Thank you for providing the Minnesota Department of Health (MDH) with the opportunity to comment on the Supplemental Draft Environmental Impact Statement (SDEIS) for the NorthMet Mining Project and Land Exchange.

Ms. Fay  
NorthMet  
Page 2  
March 13, 2014

Figure 1  
Known and Estimated Well Locations in Relation to  
NorthMet Plant Site Surface and Groundwater Flowpaths

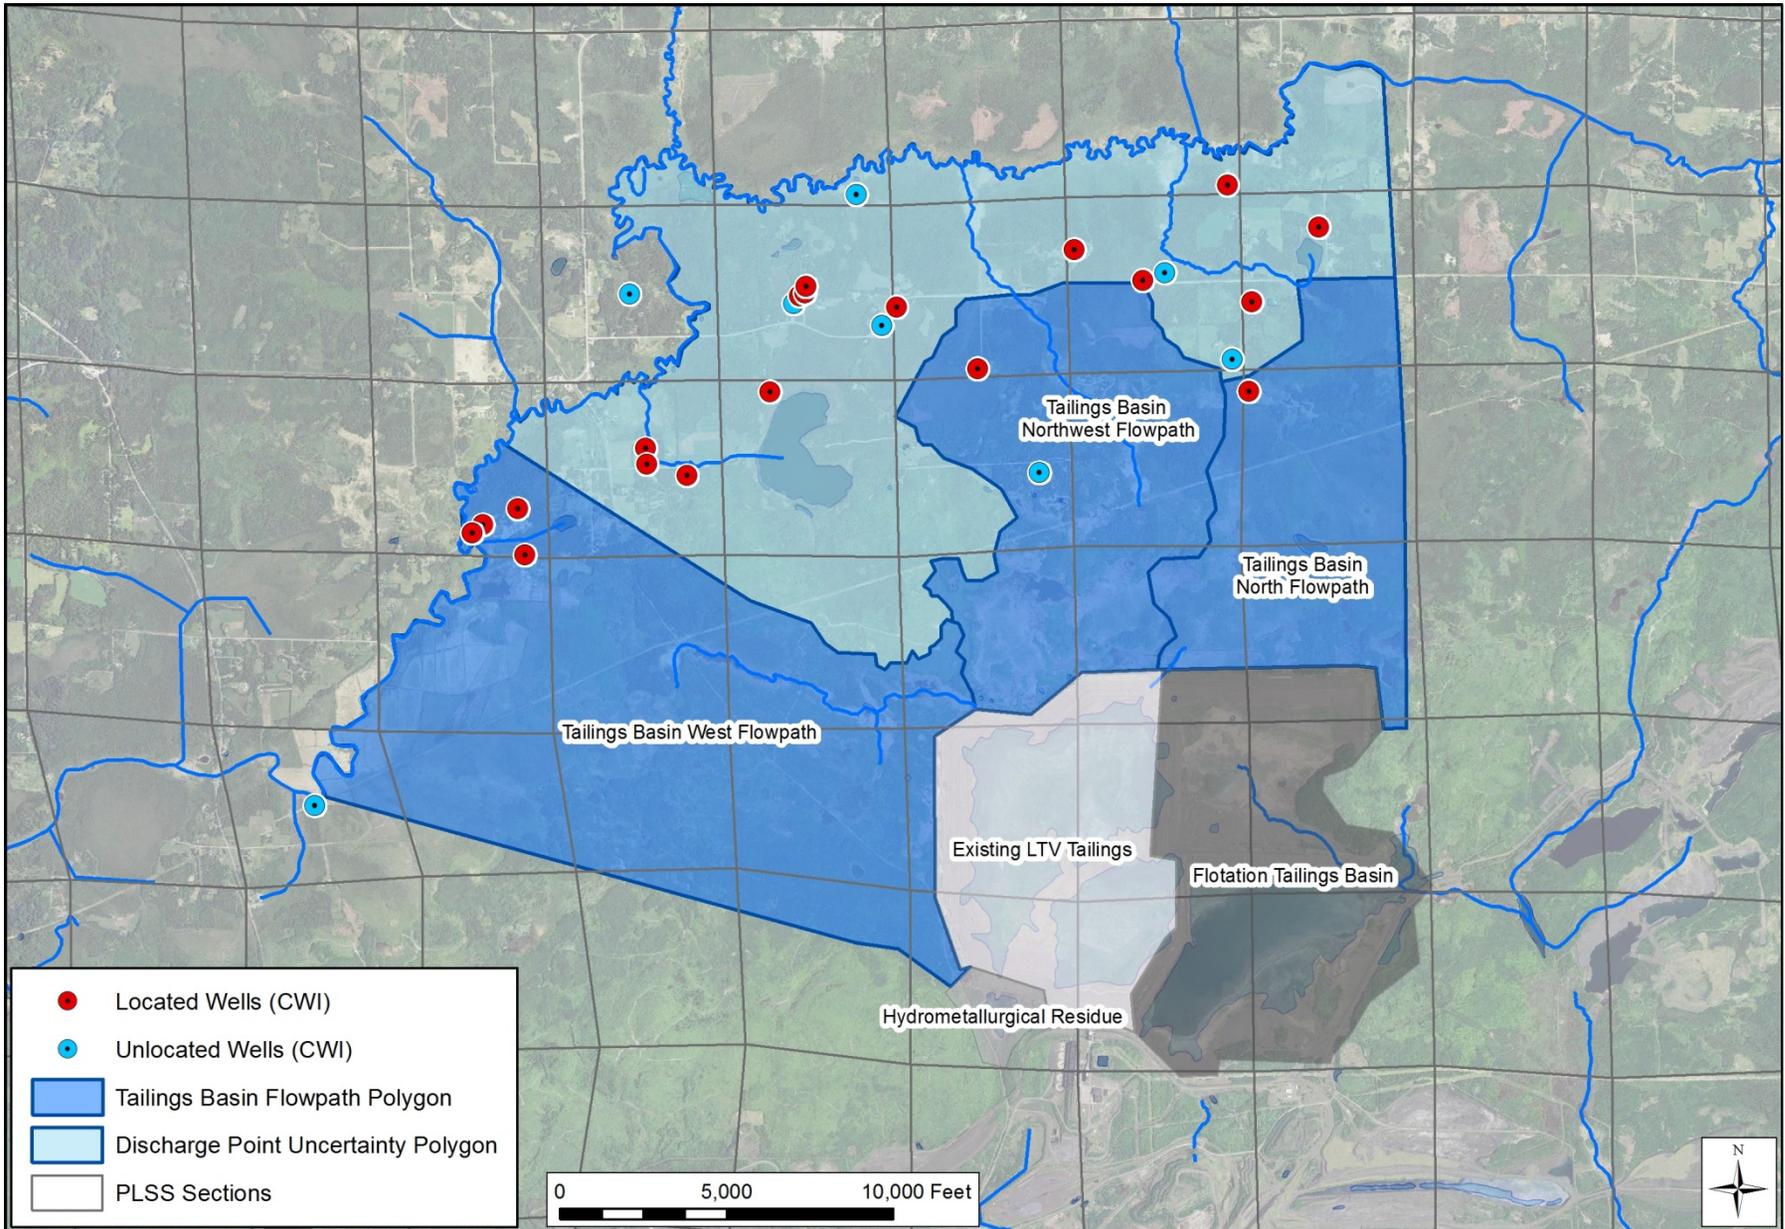
Figures 5.2.2-4 and 5.5.2-6 in the SDEIS outline the groundwater flowpaths along which contamination from the NorthMet mine and plant sites is projected to flow toward the Partridge and Embarrass Rivers. MDH staff conducted a preliminary comparison of these two areas with a search of well locations from the CWI database to assess the impacts that this proposed mining action could have on local domestic wells that are either within the delineated flowpath zones or are between the flowpath zones and the Partridge or Embarrass River. The area between the flowpath zones and the rivers was incorporated into the analysis to address uncertainty in discharge points along tributary streams between the plant and the Embarrass River.

Two sets of well data were assessed: located wells (wells that either have locations verified and recorded using GPS or that have been field-verified to six quarter-sections) and unlocated wells (wells whose locations are estimated based on information provided by well contractors at the time of well construction). Our assessment shows that there were no well records in CWI between the mine site and the Partridge River. However, Figure 1 (attached) shows that 19 located and eight unlocated wells with records currently within CWI met our search criteria for the area between the Plant Site and the Embarrass River, and by inference could be impacted by this mining activity. It should be noted that these numbers likely represent minimum values, as there may be unlocated wells in the area that pre-date the Minnesota state Well Code in either of the modeled zones. These wells that pre-date the code would need to be inventoried, located and input into CWI. Any unused and unsealed wells found during the inventory could be conduits through which a contaminant plume could more quickly propagate, and therefore would need to be sealed as per current Well Code by the parcel owner, possibly with PolyMet Mining, Inc.'s assistance. Also, PolyMet Mining, Inc. should take every opportunity to collect baseline samples for any new wells that might be drilled in the area.

- Provide dissolved oxygen data if available or complete measurement.
- Conduct a thorough inventory and baseline water quality assessment of existing wells prior to the initiation of any mining activities so that any future degradation of drinking water quality related to mining activities can be identified and remediated. This inventory and assessment should include located and unlocated wells.

- Properly seal any unused and unsealed wells found during the inventory.
